THE CITY OF WALTHAM  
MASSACHUSETTS

**Boiler Replacement, Waltham Library**

**ADDENDUM NO. 3**

Sept 12, 2017

- NOTES:
- DUCTWORK NOT SHOWN FOR CLARITY

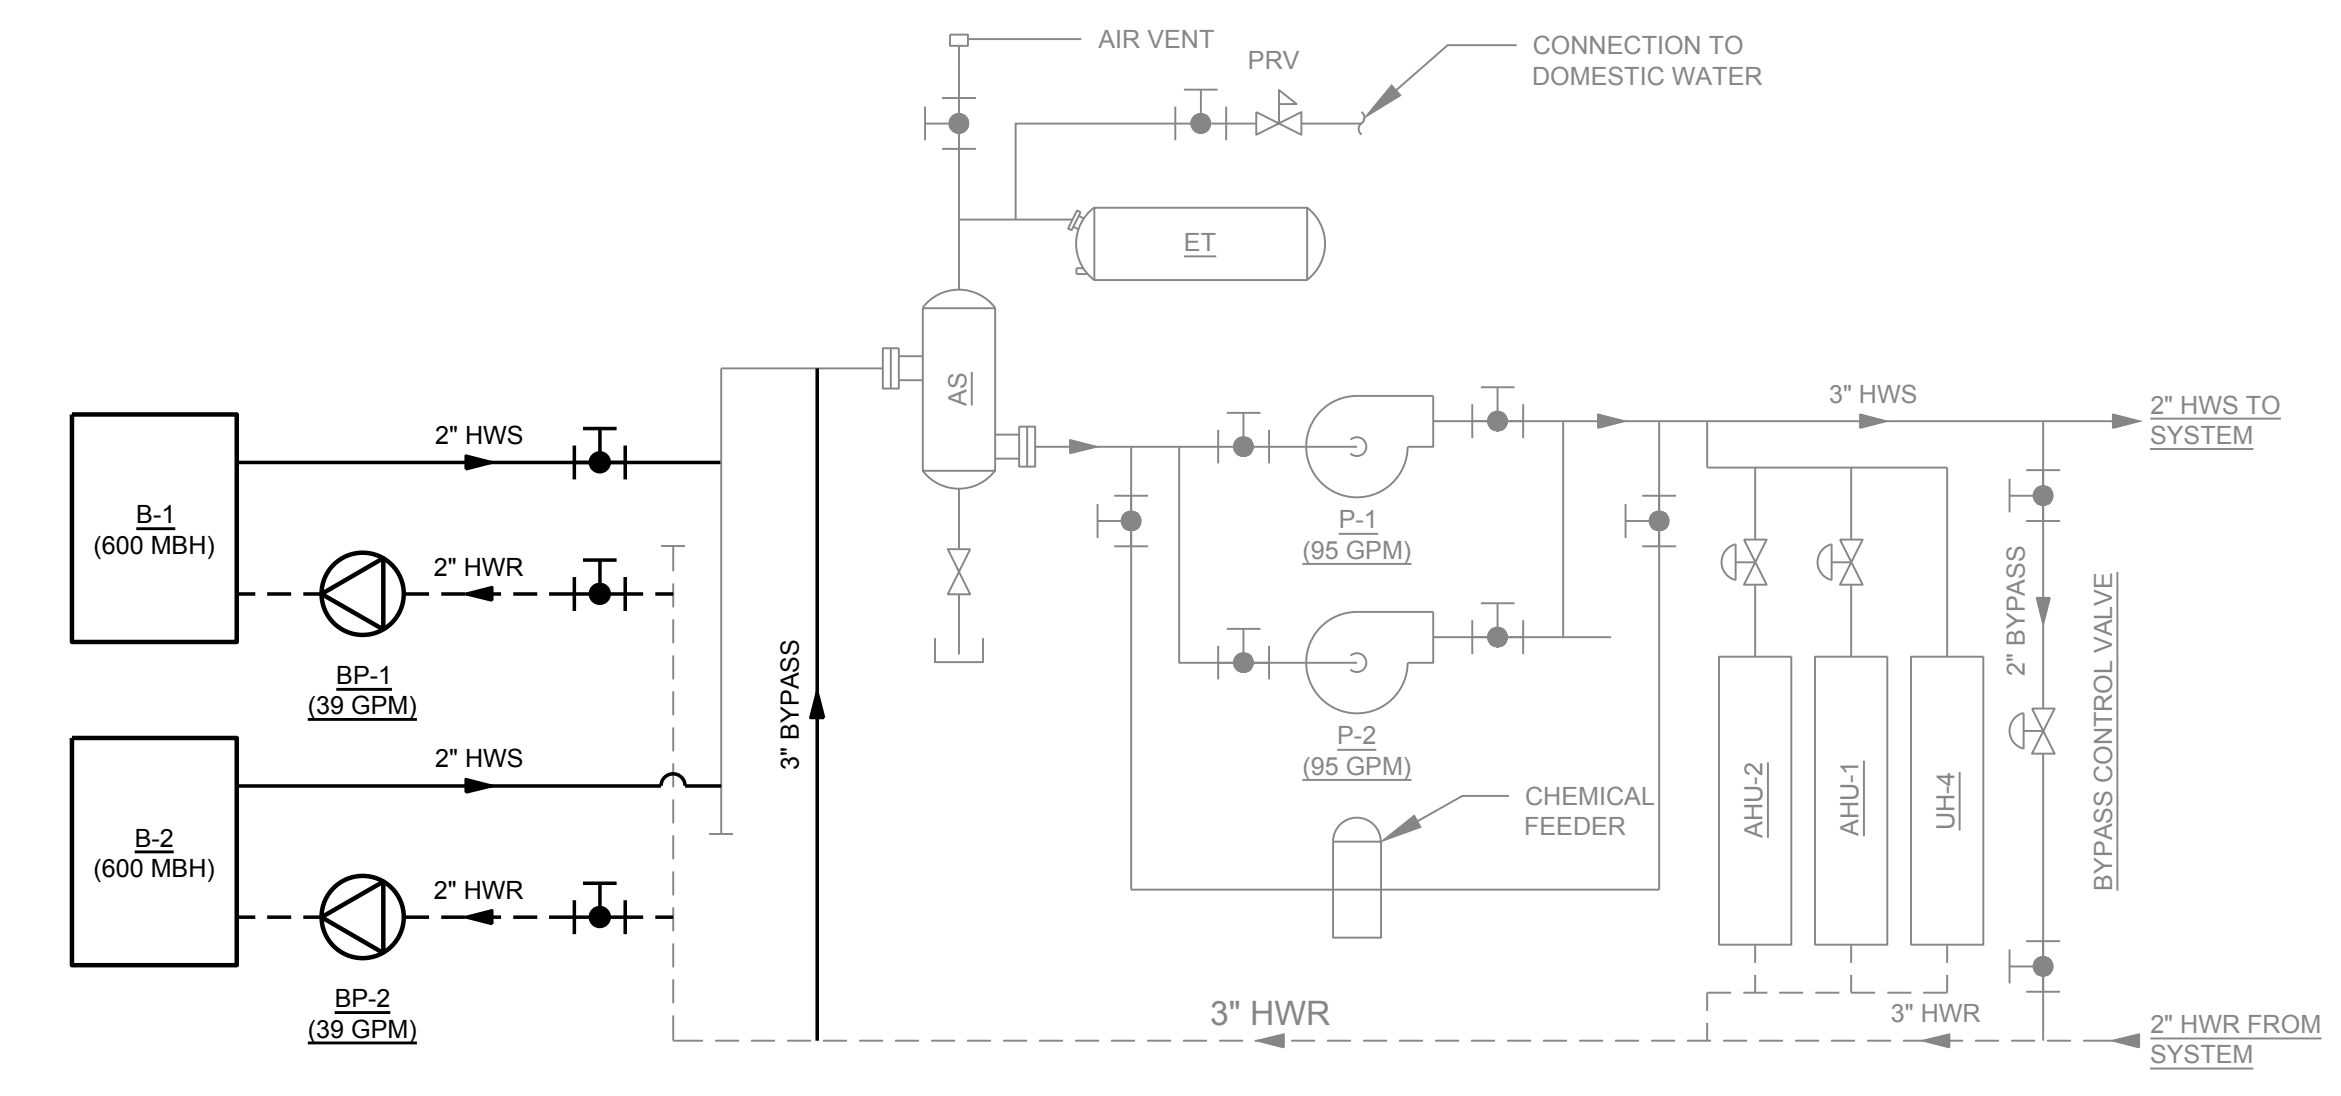
b) **DELETE** Drawing M-200 in the bid document and **REPLACE** WITH THE ONE ATTACHED HERE. Drawing M-200 has also been revised to require the contractor to provide a cap on the existing roof curb after the B-1, 2, 3 flue has been removed.

SEQUENCE OF CONSTRUCTION NOTES

- HEATING SYSTEM DOWNTIME SHALL BE COORDINATED WITH THE OWNER, AND SHALL ONLY BE ALLOWED ON FRIDAY, SATURDAY AND SUNDAYS UNLESS TEMPORARY BOILERS ARE PROVIDED.

M100

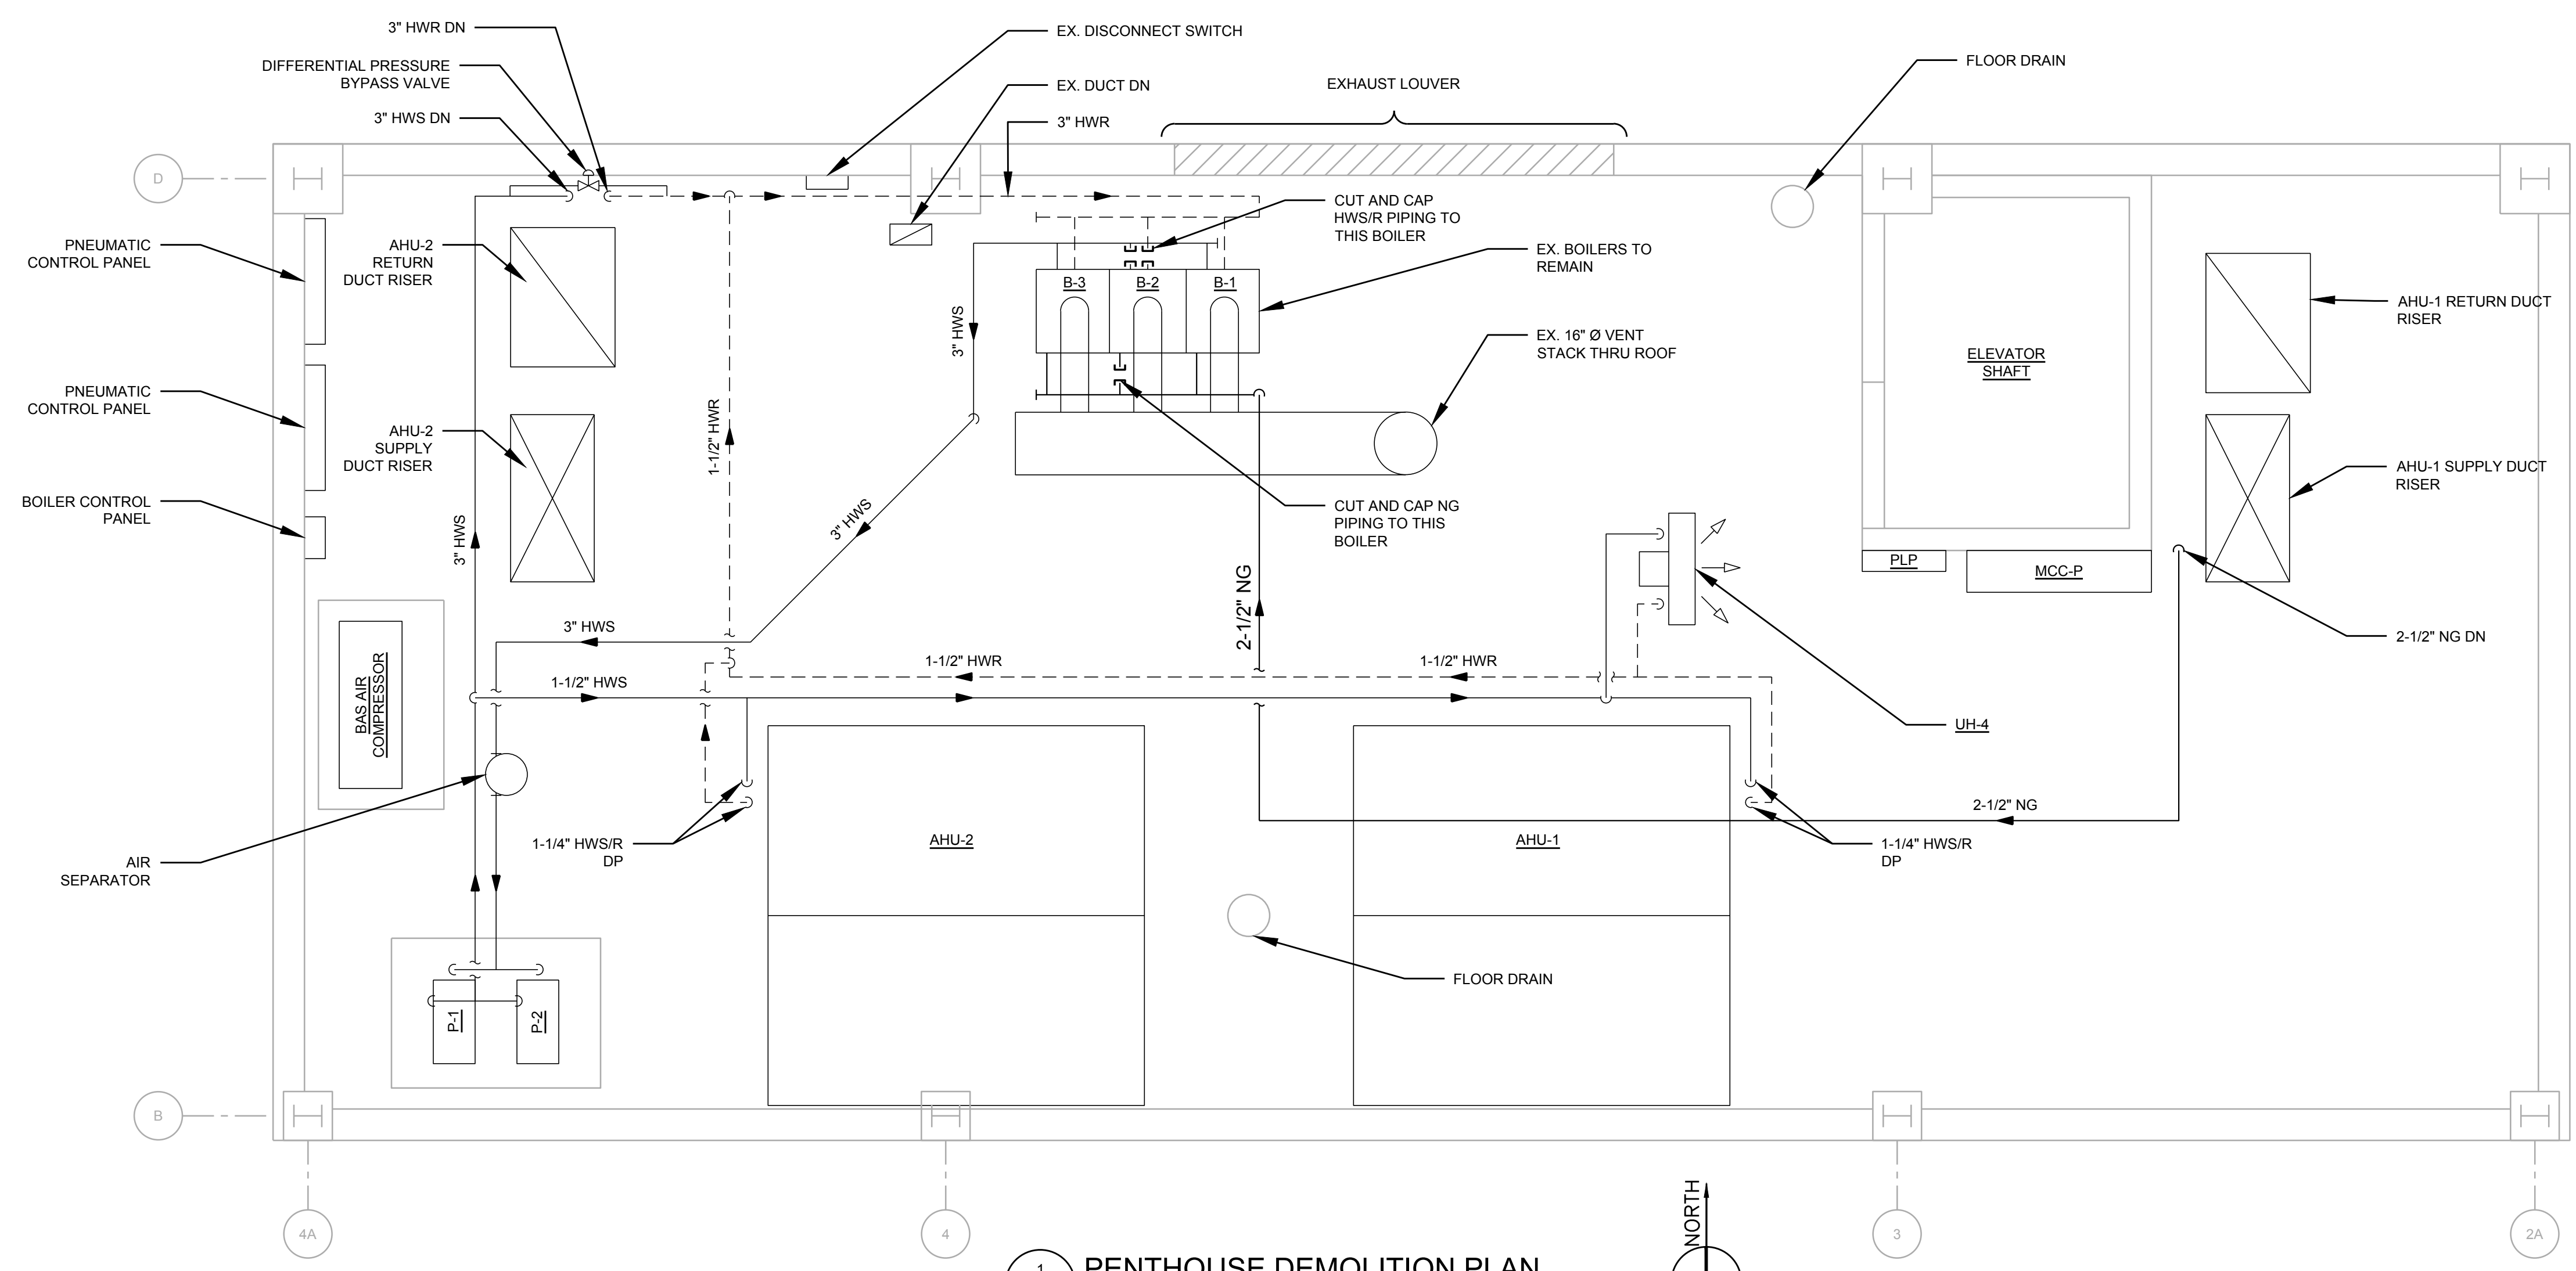
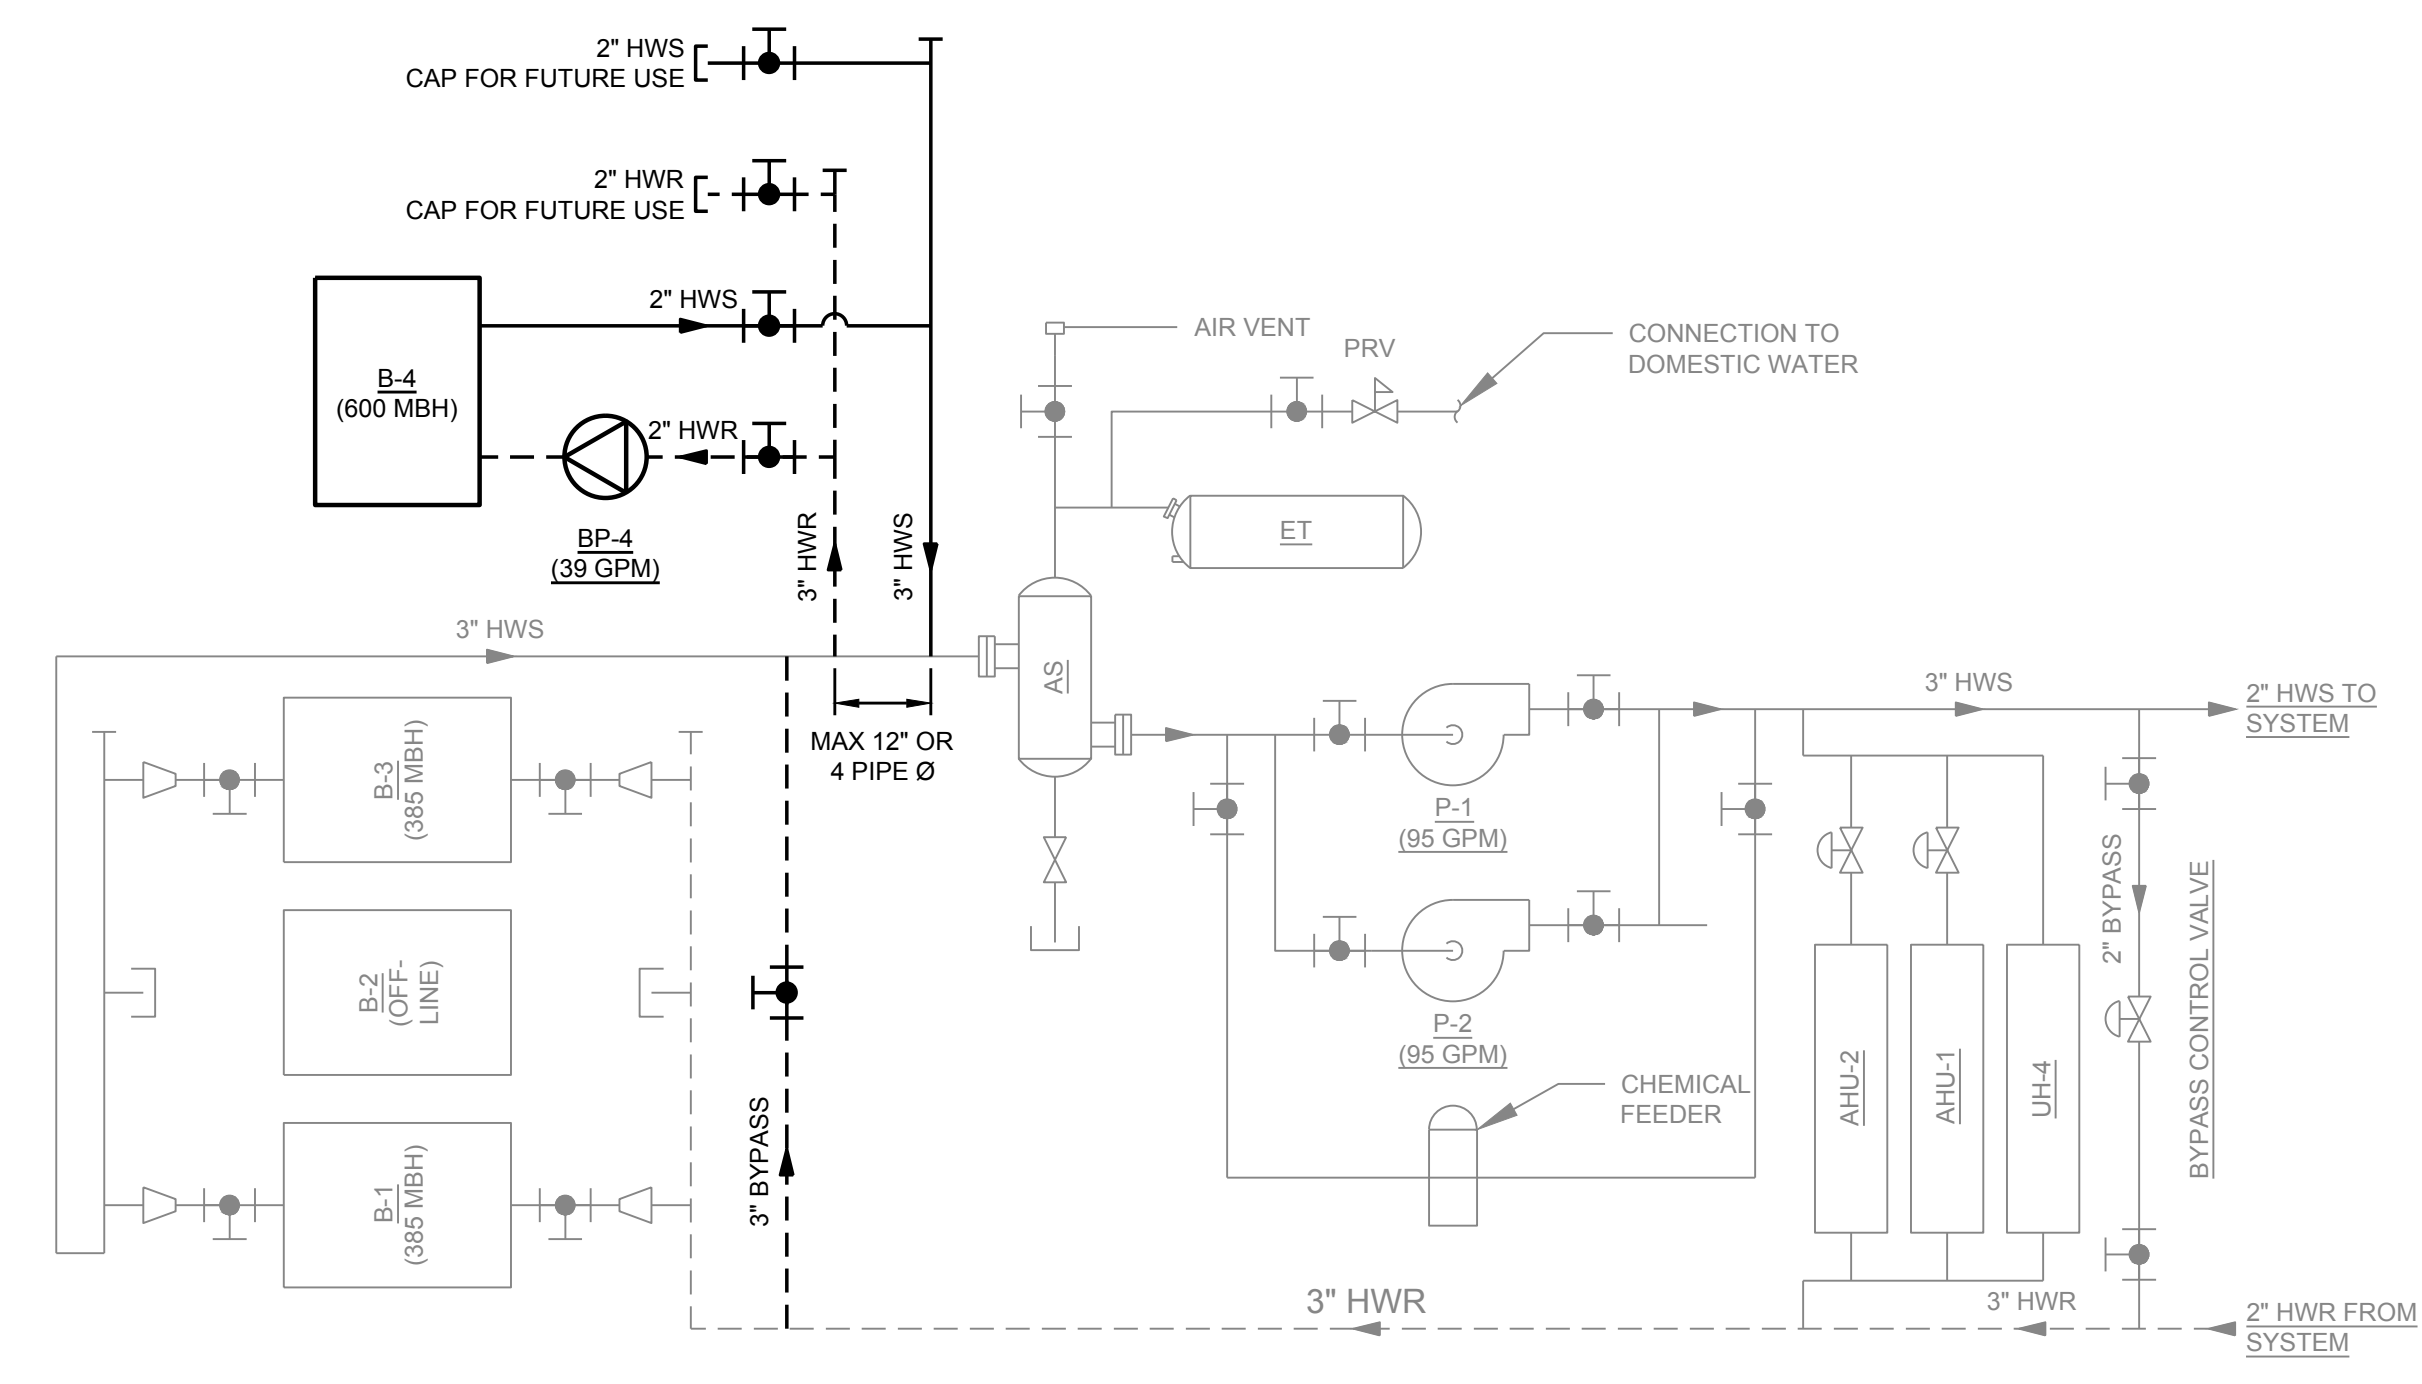
a) **DELETE** Drawings M-100 in the bid document and **REPLACE** WITH THE ONE ATTACHED HERE. The Drawings (M100 and M-200) have been modified to include the 'Sequence of Construction Notes' section, which addresses downtime of the heating system as discussed during the pre-bid meeting. Downtime will only be permitted Friday, Saturday, and Sunday, and will be coordinated with the owner.

SEQUENCE OF CONSTRUCTION NOTES

- HEATING SYSTEM DOWNTIME SHALL BE COORDINATED WITH THE OWNER, AND SHALL ONLY BE ALLOWED ON FRIDAY, SATURDAY AND SUNDAYS UNLESS TEMPORARY BOILERS ARE PROVIDED.
